Client Manchester City Council																																																	
Project Our Town Hall																																																	
Drg Title Kerbs, Edges & Channels 2 of 3																																																	
Created on	Created by	Approved by

19.09.18	SR	SR/KR																																															
Scale	Size	Workstage																																															
1:250	A1	Stage 5																																															
Drg No.		Suitability	Revision																																														
OTH-PLA-EE-ES-DWG-L-1008		S4	C03

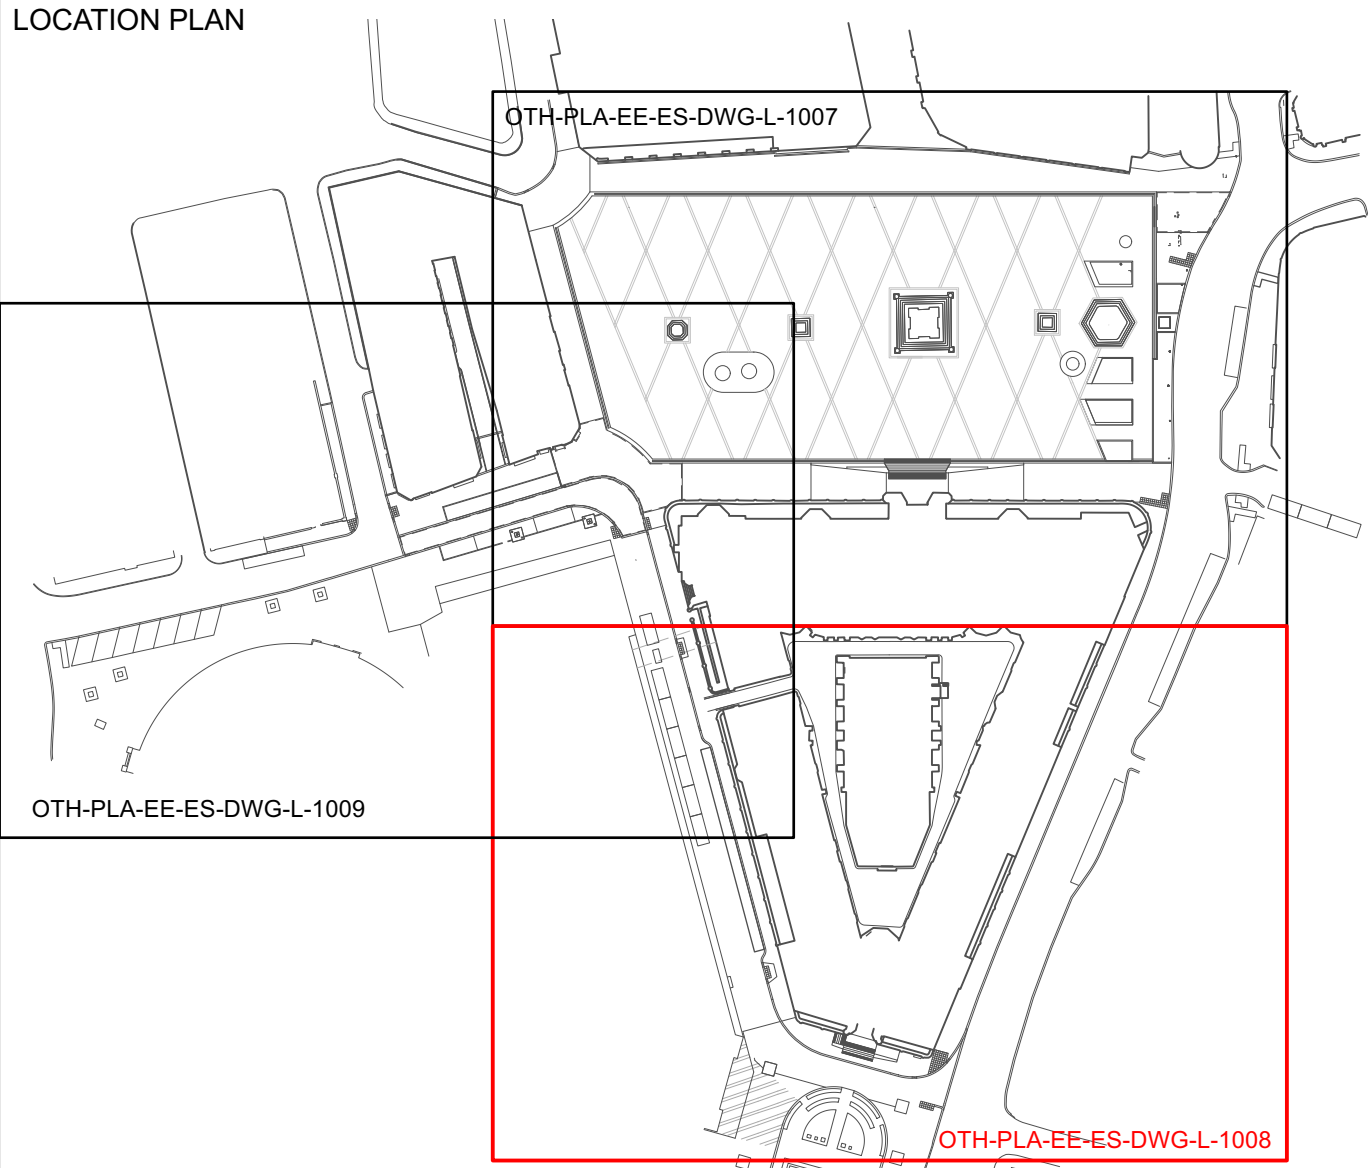
1. Stone K2 edge omitted at Princess St, replaced with metal edge K4.4. Addition of gravel margin with timber edge around bollards.

2. Mount St kerb notes added - transition from 25mm to 6mm. Minor amendment to kerb position to avoid service cover.
